Model: Moto Guzzi 1200 8V engines

Subject: Operations on valve bucket tappets

Model: Moto Guzzi 1200 8V engines

Subject: Operations on valve bucket tappets

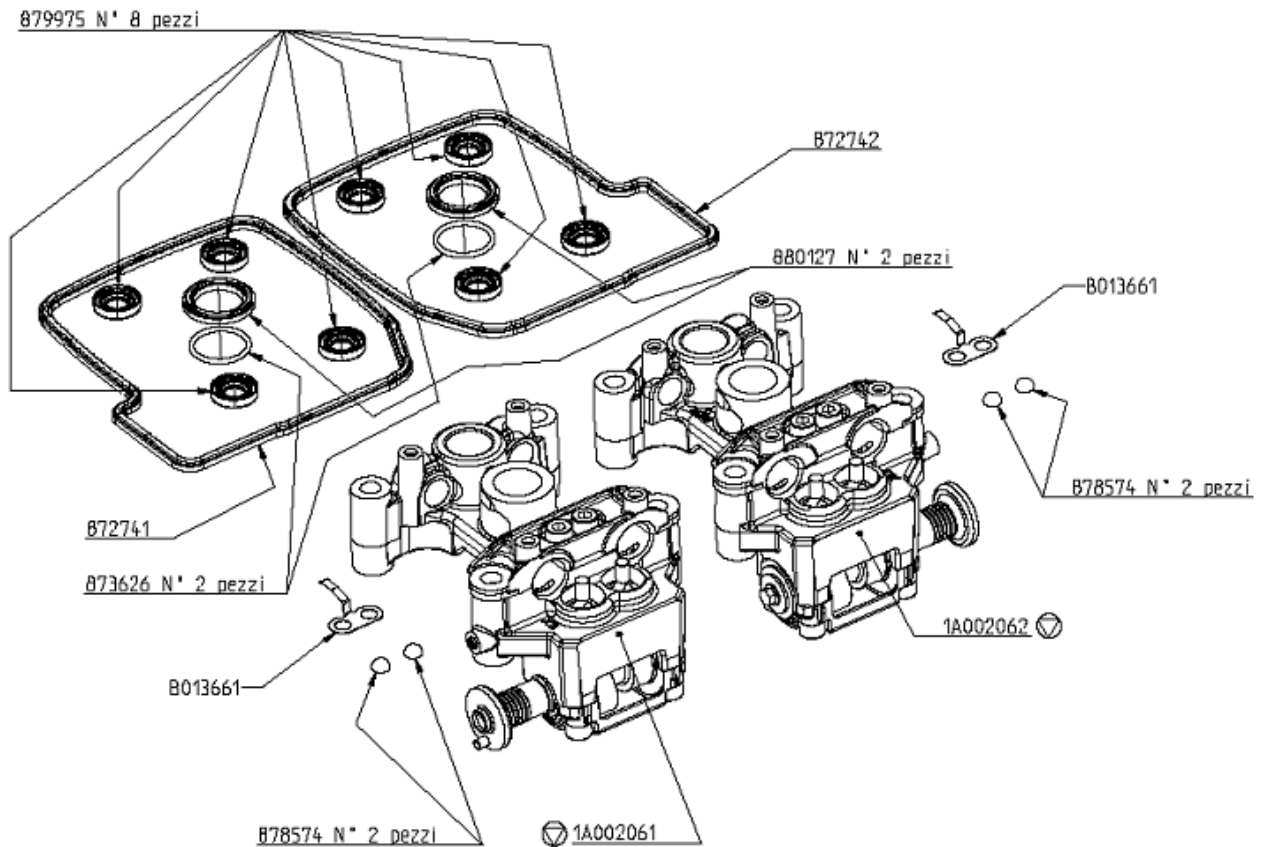
To verify whether the vehicle can be modified with **kit A** remove the timing cover and check whether it is the floating type, which can be recognised by the presence of the circlip in the spark plug hole area:

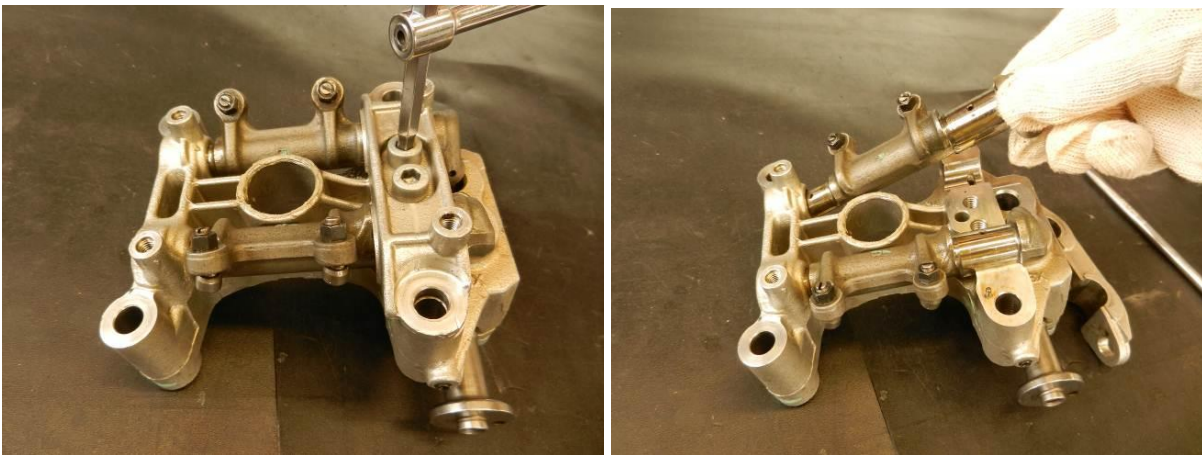
As per Workshop Manual procedure, access the timing system by removing the cylinder head cover, paying attention to the internal gaskets; remove the timing gear from the camshaft and then remove the timing system cam tower.

P/N 878524

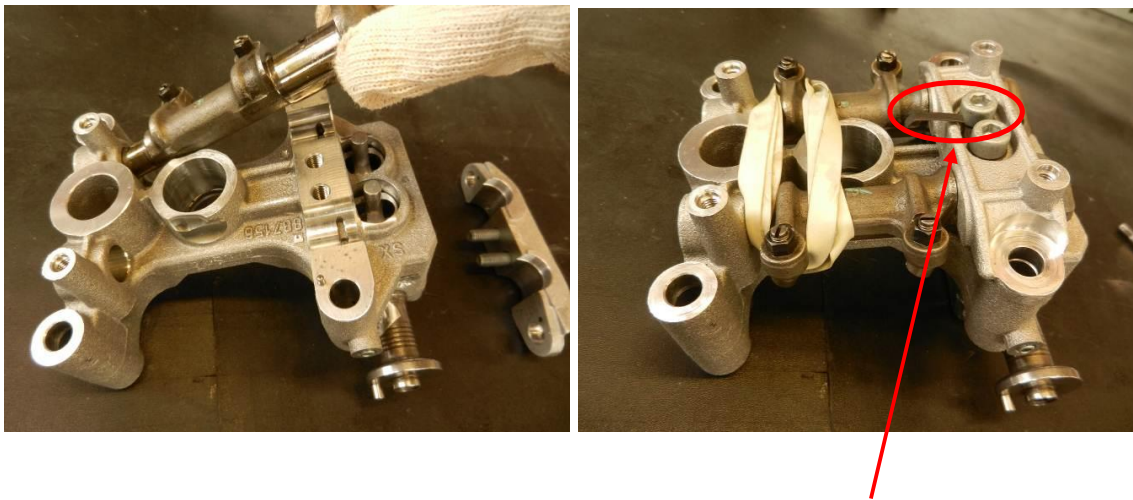
Place the pads P/N 878524 in the relative seats with the aid of a layer of grease so that they hold the position.

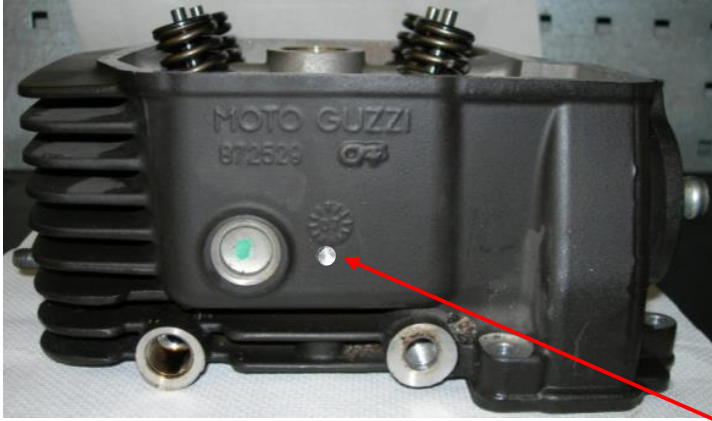
To determine if the vehicle may be modified with **kit B or C**, remove the timing cover and check that it is a **NON-floating** type cover, which is identifiable by the absence of a circlip in the spark plug hole area:

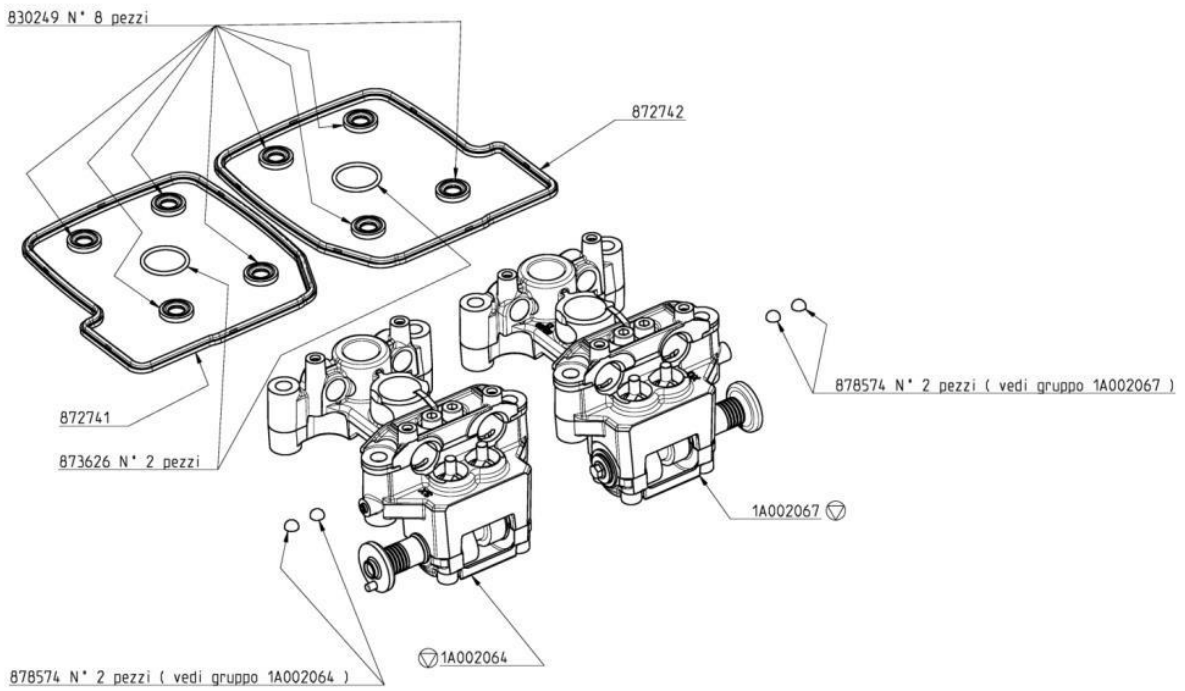
KIT B, P/N 1A002063, consists of the following components:

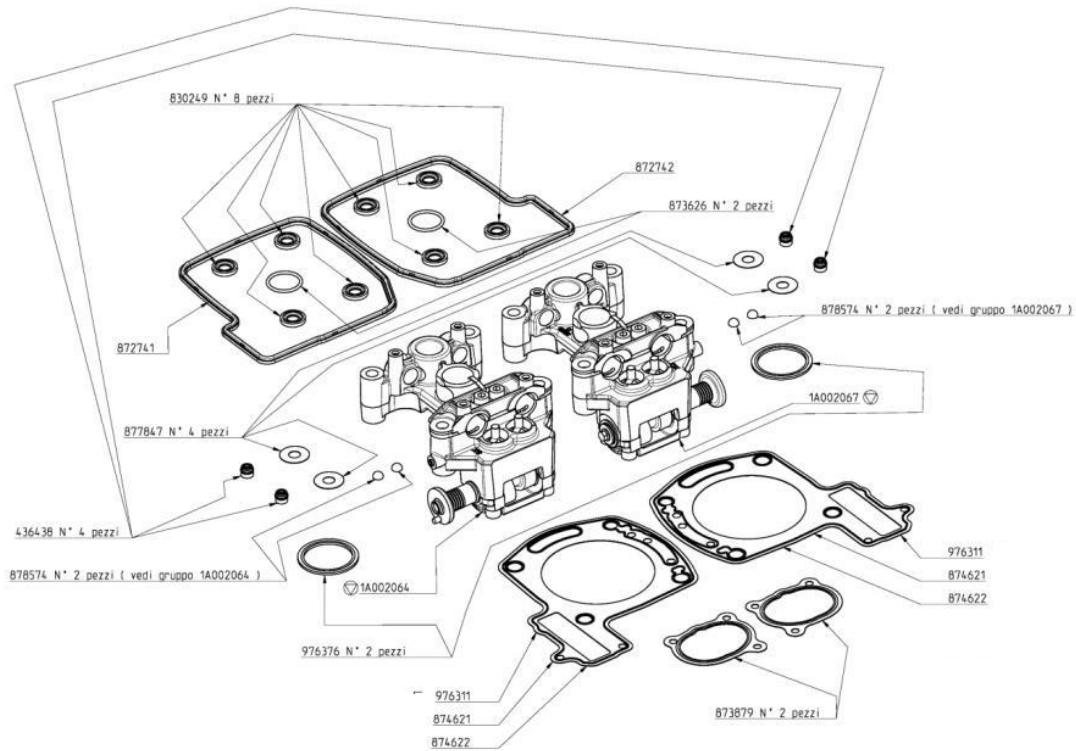
KIT C, P/N 1A002082, consists of the following components:

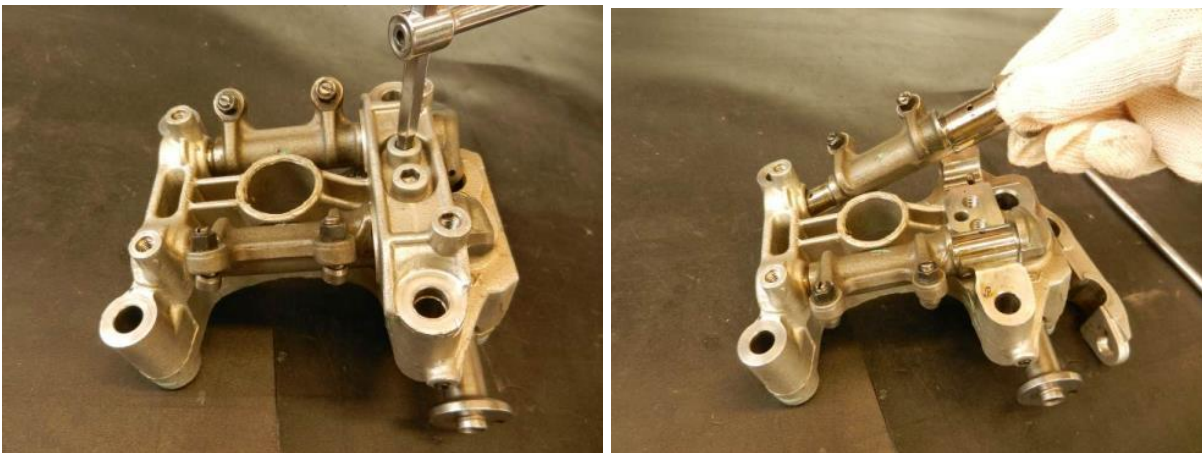
As per Workshop Manual procedure, access the timing system by removing the cylinder head cover, paying attention to the internal gaskets; remove the timing gear from the camshaft and then remove the timing system cam tower.

P/N 878574

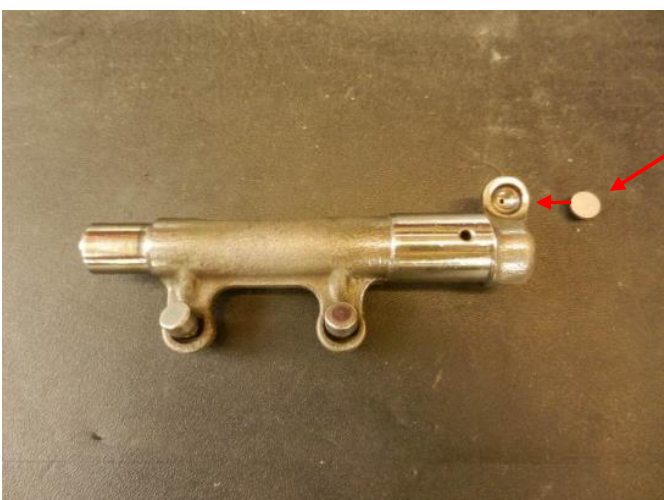
Place the pads P/N 878574 in the relative seats with the aid of a layer of grease so that they hold the position.

P/N B013661

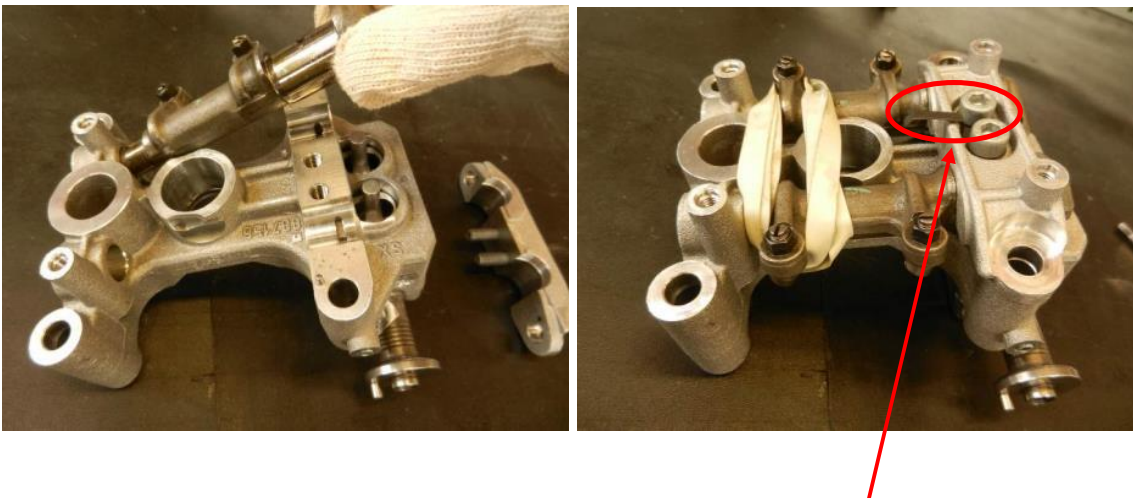
Fit the old rockers in the **new** cam tower. Fasten the rocker retainer, remembering to fit the **new** ground plate **P/N B013661** included in the kit between the cam tower and the fastener screws (tightening torque 18 Nm), discarding the old ground plate.
